# The BULLETIN OF THE BEAUX-ARTS INSTITUTE OF DESIGN

# A CREMATORY AND COLUMBARIUM

## REPORT OF THE JURY-Perry M. Duncan

FIRST MEDAL-R. P. HOOTON

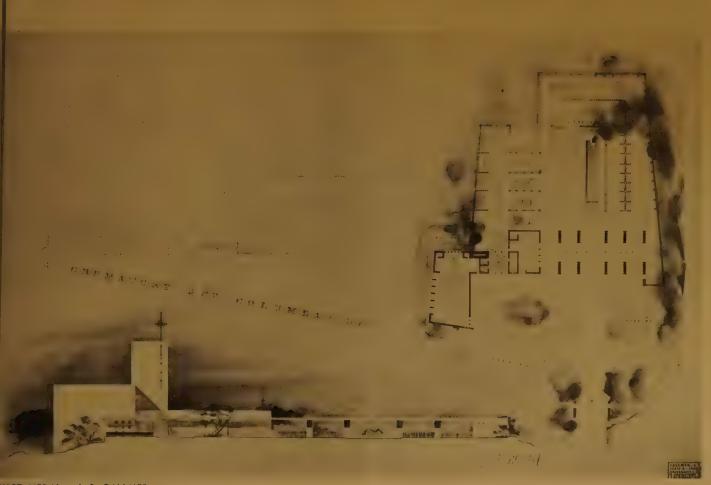
and simple scheme. All the units are well placed, and the service is splendidly handled. The chimney is made into an attractive feature. The entire project shows style and distinction.

IRST MEDAL - J. P. CALLMER

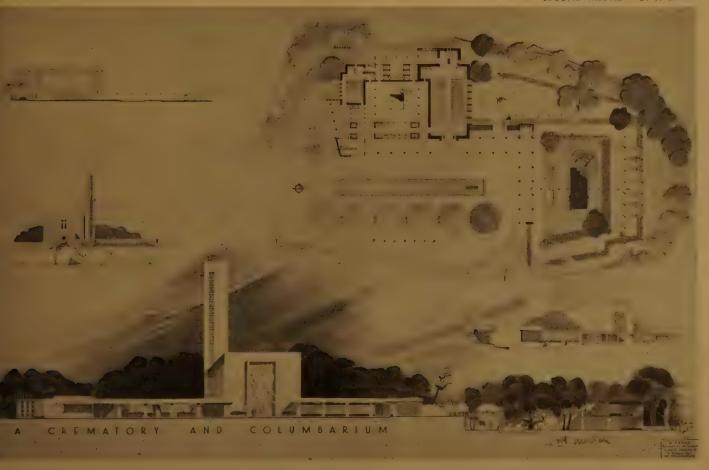
J. P. Callmer, University of Illinois: With a general plan well conceived throughout, the Columbarium receives the importance it deserves. The Parking, divided into two parts, is a pleasing feature. The small mosaic pattern shown in the link between the two chapels is a false note, rather unimportant, but out of character with the stately simplicity of the rest of the design.
